NOTICE OF DECISION

PARTITION / CLASS 1 ADJUSTMENT CASE NO.: PAR-ADJ18-12

SUMMARY: A proposed partition to divide a lot along the southerly side of Trade Street SE into two parcels with a Class 1 Adjustment for lot width and depth ratio.

**IN THE MATTER OF THE
TENTATIVE APPROVAL OF
PARTITION PLAT NO. 18-12;
2160 TRADE STREET SE**

2160 TRADE STREET PARTITION
EXISTING CONDITIONS
& DEMOLITION PLAN

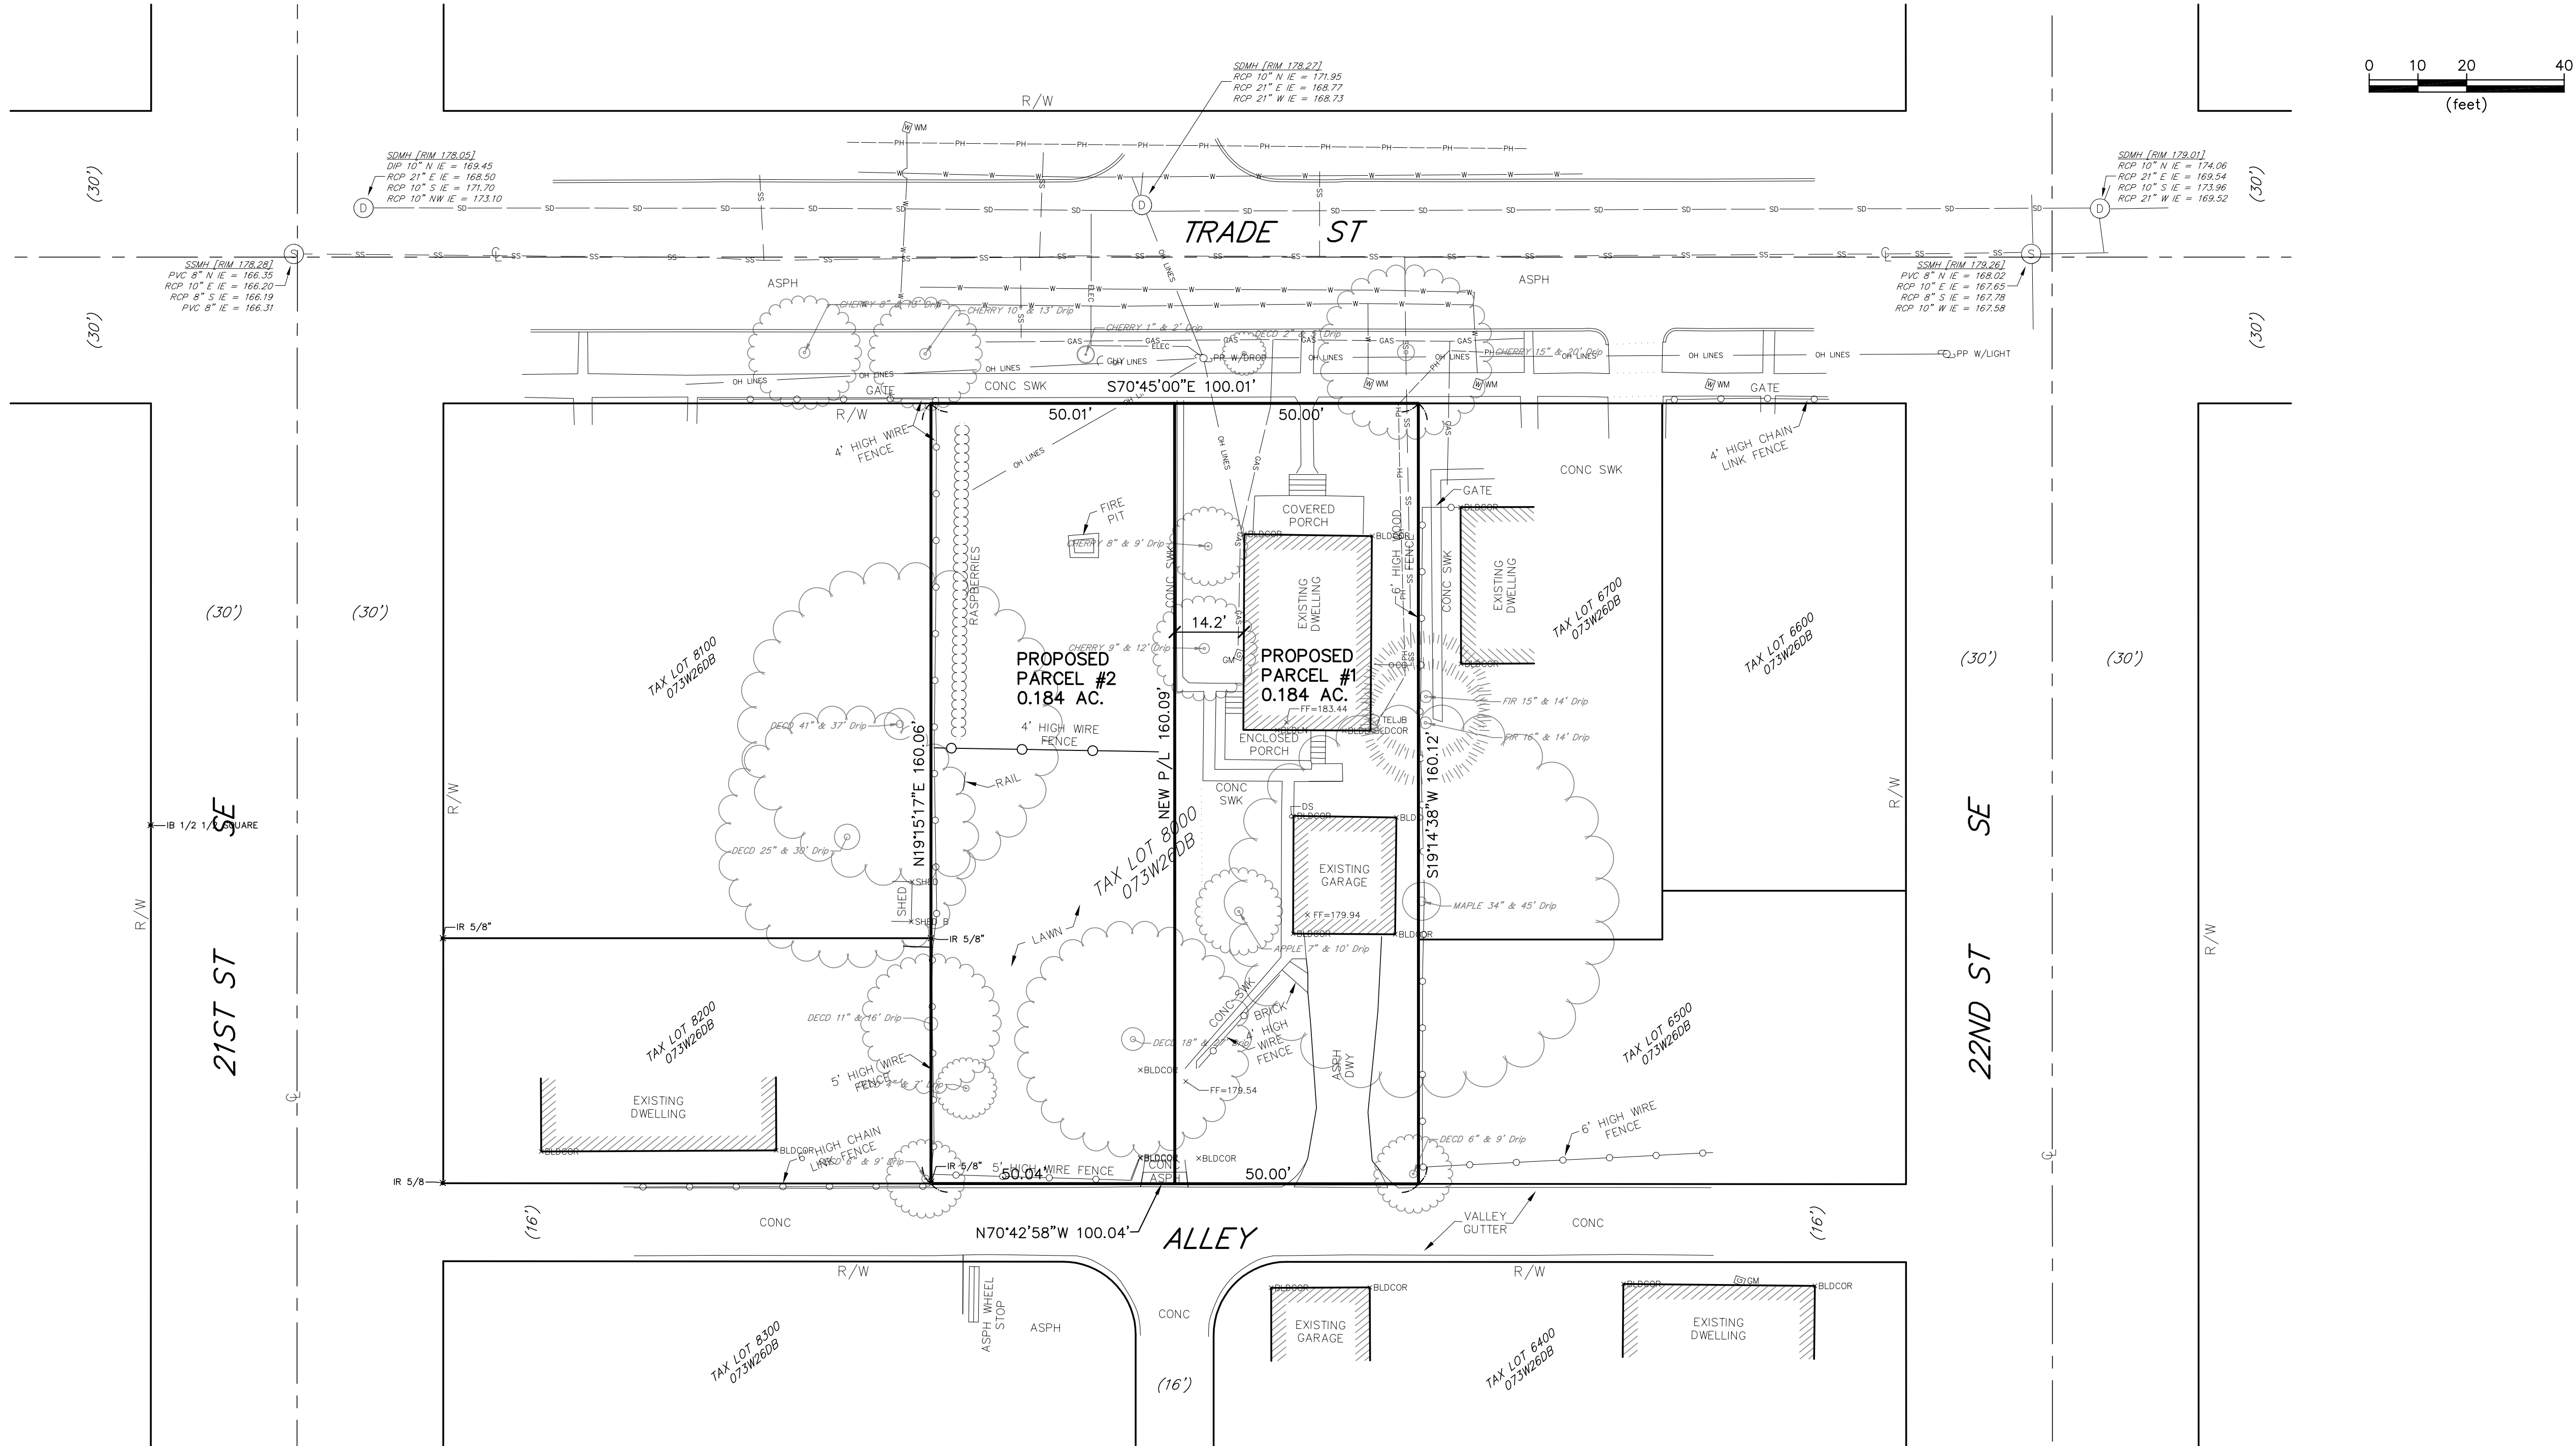
The subject property includes an accessory structure that, if retained, would straddle the proposed property line, which is also not allowed. To ensure accessory structure is not retained, creating a nonconforming development, the following condition shall apply:

Condition 1: Prior to final plat approval, the applicant shall obtain a demolition permit and remove the existing accessory structure on the site that would straddle the new property line.
